APPLICATION NO.	FILING DATE	FIRST NAMED INVENTOR	ATTORNEY DOCKET NO.	CONFIRMATION NO.
09/873,144	06/01/2001	Erik K. Jurvis	25039A	3286

# Office Action Summary

## DETAILED ACTION

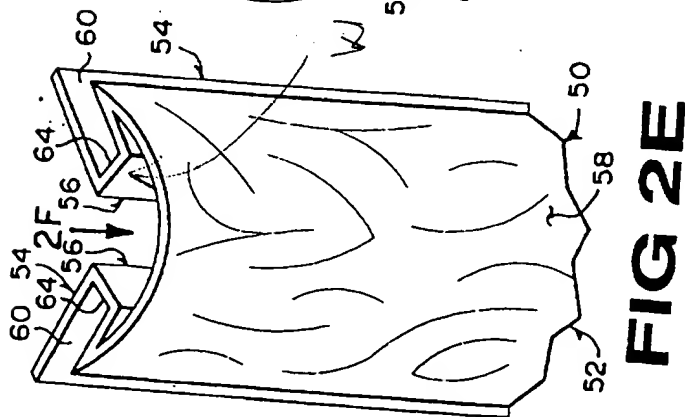
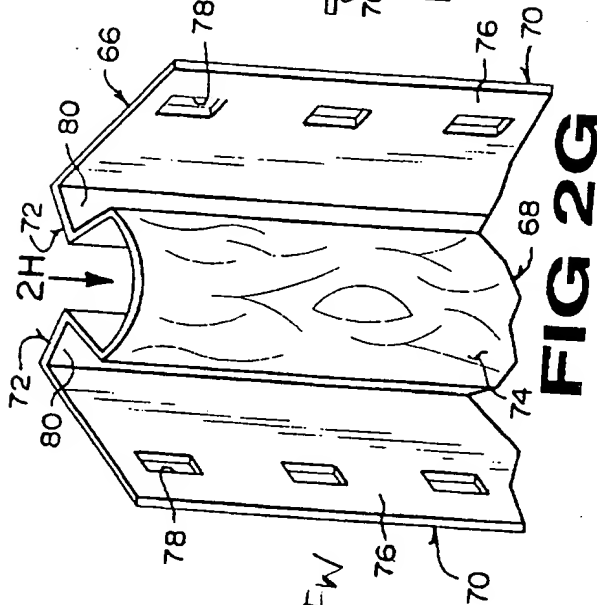
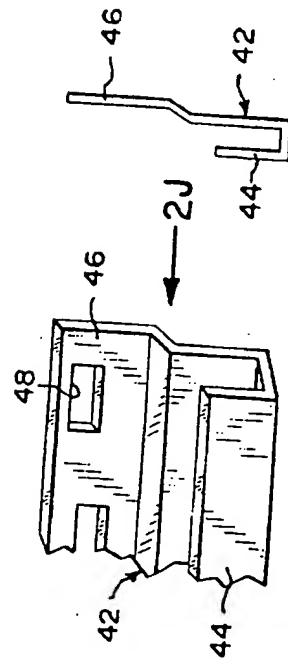
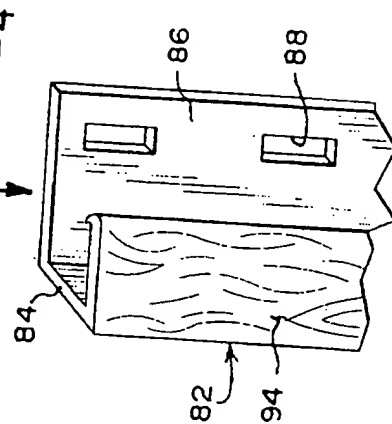
3. Claims 1,6 and 7 are rejected under 35 U.S.C. 102(b) as being anticipated by US Patent #5,090,174 to FRAGALE. FRAGALE discloses a component for receiving a plurality of siding members (30) for covering the wall including an elongated body (10) having first and second receivers (28) on opposing sides of the body (10). The component includes a first wall (11) and an end wall (W), see the marked-up attachment wherein the endwalls (E) are parallel.
